Checklist for P.E. Annual Inspection for CCR Surface Impoundments, § 257.83(b)

Sikeston BMU Sikeston Power Station Fly Ash Surface Impoundment

Annual Inspection

SIKESTON POWER STATION – FLY ASH POND
2020 ANNUAL INSPECTION CHECK SHEET

FIGURE 1

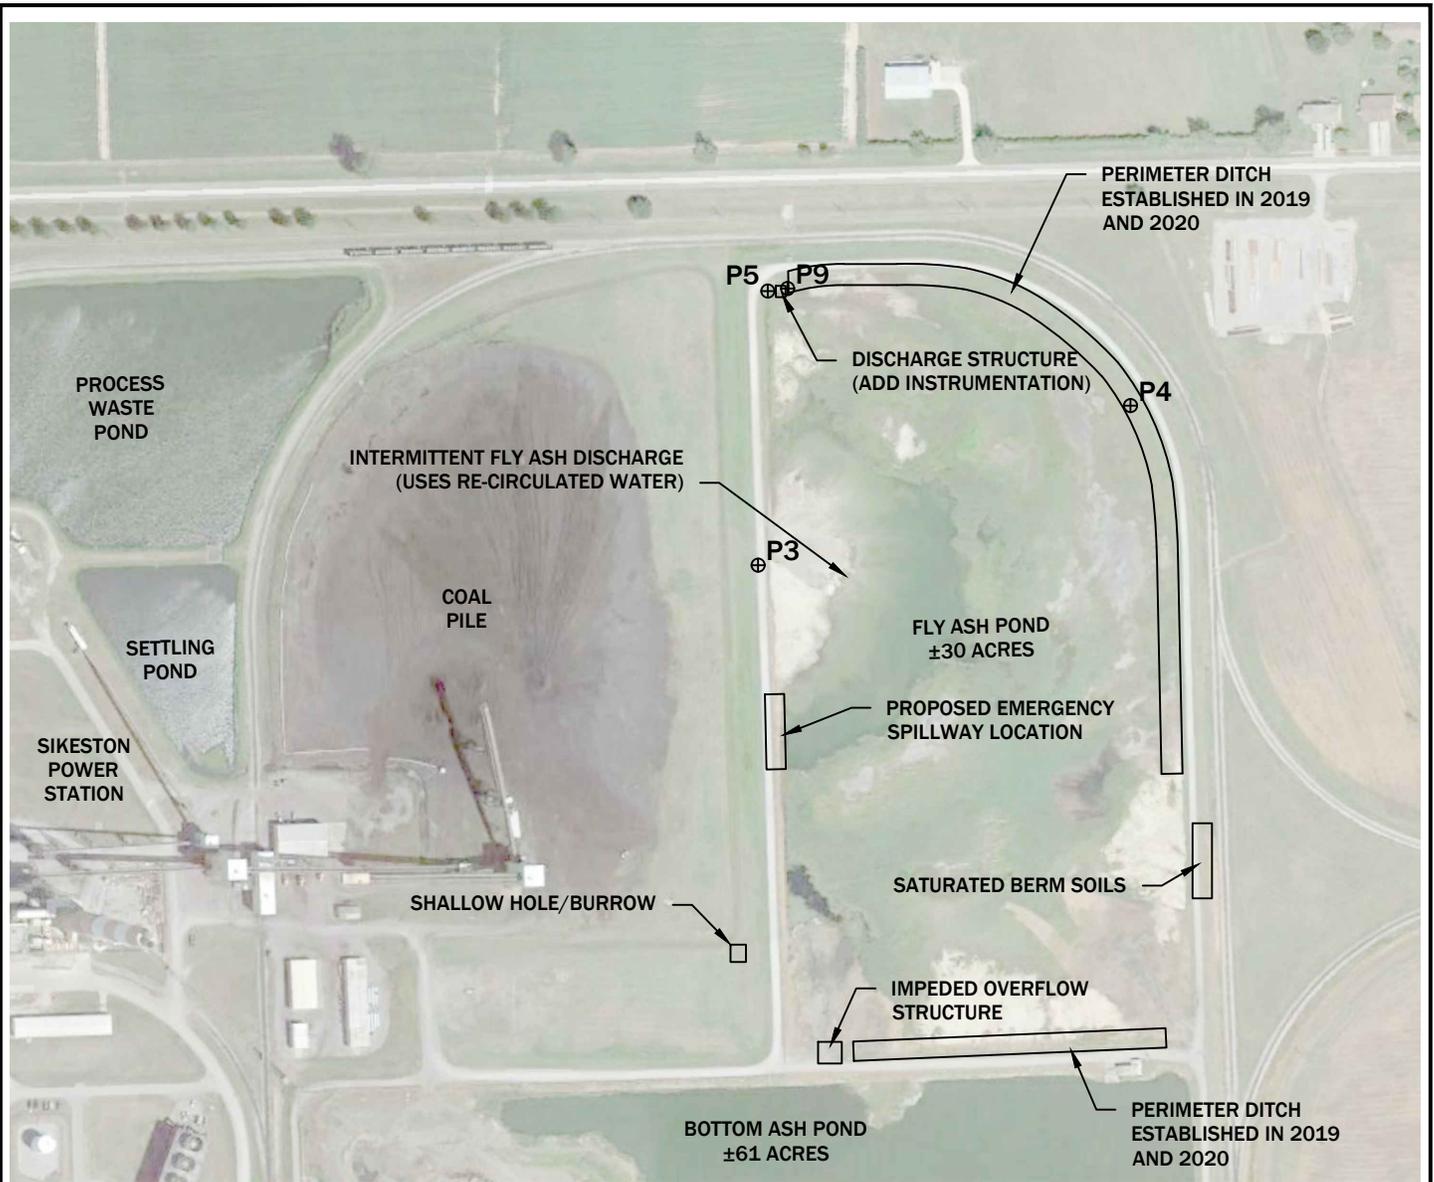
1. The location of observations on attached plan sheet (Figure 1).

1. MINOR MAINTENANCE ITEMS INCLUDE:
 - a. CLEAN SEDIMENT AND VEGETATION FROM DISCHARGE STRUCTURE.
 - b. ADD INSTRUMENTATION (STAFF GAUGE).
 - c. REPAIR INOPERABLE GATE VALVE TO THE PROCESS WATER POND OR DEVELOP AN EMERGENCY SPILLWAY.
 - d. EXCAVATE INTERIOR STORMWATER CHANNEL 2 FEET DEEP ALONG POND PERIMETER (WHERE REQUIRED)
2. REQUIRING FURTHER OBSERVATION INCLUDE:
 - a. SATURATED BERM SOIL ALONG SOUTHEAST BERM.
 - b. MONITOR FOR BURROWING ANIMALS AND REMOVE THEM AS NEEDED.
3. ITEMS IDENTIFIED DURING THE ANNUAL INSPECTION WHICH DO NOT REQUIRE MAINTENANCE:
 - a. THE IMPEDED OVERFLOW STRUCTURE BETWEEN THE BOTTOM ASH POND AND THE FLY ASH POND.
